Agenda
Village of Glen Ellyn
Architectural Appearance Commission Special Meeting
Wednesday, August 16, 2023
7:00 PM
Glen Ellyn Civic Center, Galligan Board Room

REQUEST: The petitioner is requesting an Exterior Appearance Review for construction of a Popeyes Louisiana Kitchen restaurant. The proposed restaurant is 2,515 square feet. The restaurant will contain a drive-through, as well as interior order counter and seating for 24. To proceed with the project, the petitioner will need to receive approval of the Exterior Appearance of the proposed improvements. A Zoning Map Amendment, Special Use Permit and Zoning Variations are also being sought. These additional issues will be reviewed by the Plan Commission. Recommendations from both citizen review bodies will be forwarded to the President and Village Board of Trustees.

A5.0

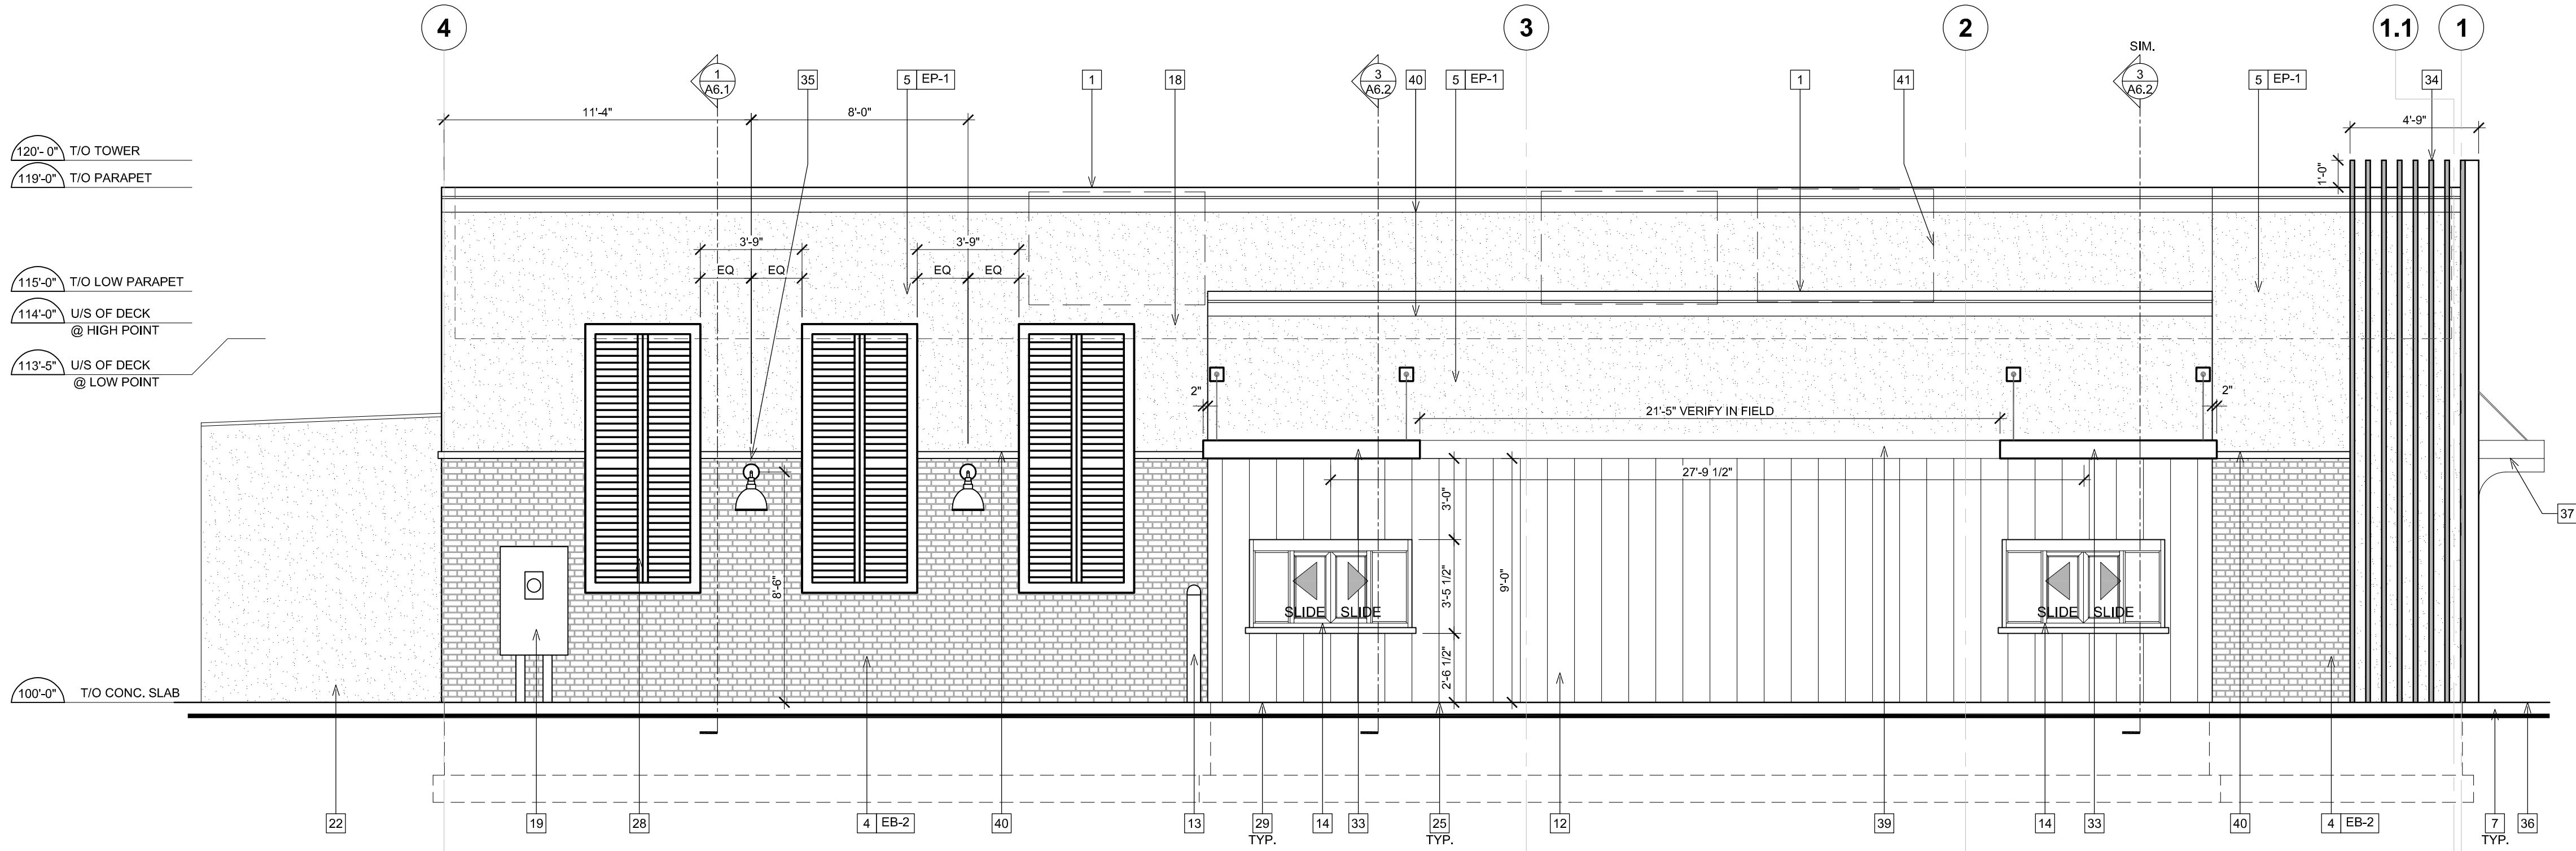
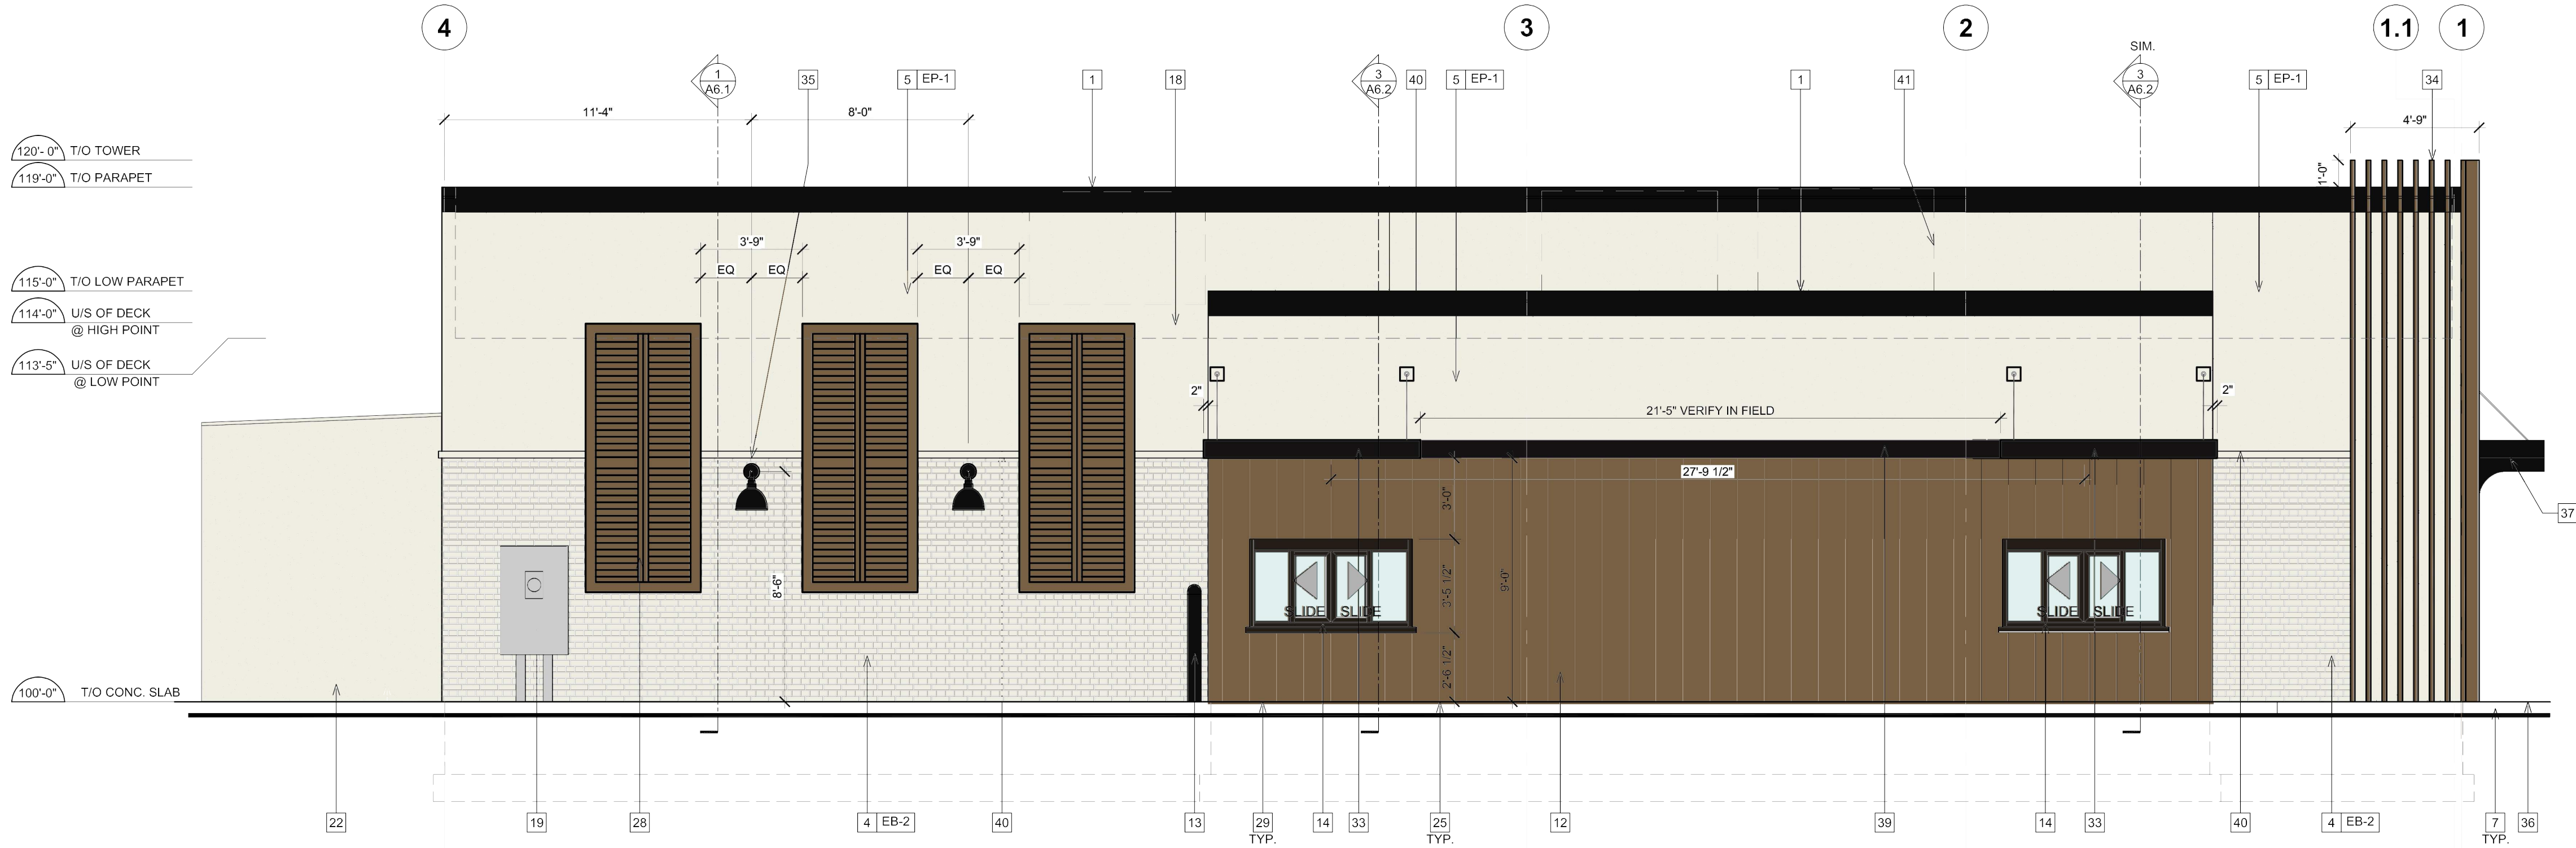
Again, the petitioner has revised their plans to utilize the Nichiha brick for the lower two feet on the east and south facades thus raising the storefront windows up from the ground plain.

The revised plan being presented to the Commission has been revised, eliminating the “pops of color” in the canopies, window surrounds and shutters.

Staff believes the revised plan as presented to the Commission meets this guideline.

Staff believes the revised plan as presented meets this guideline.
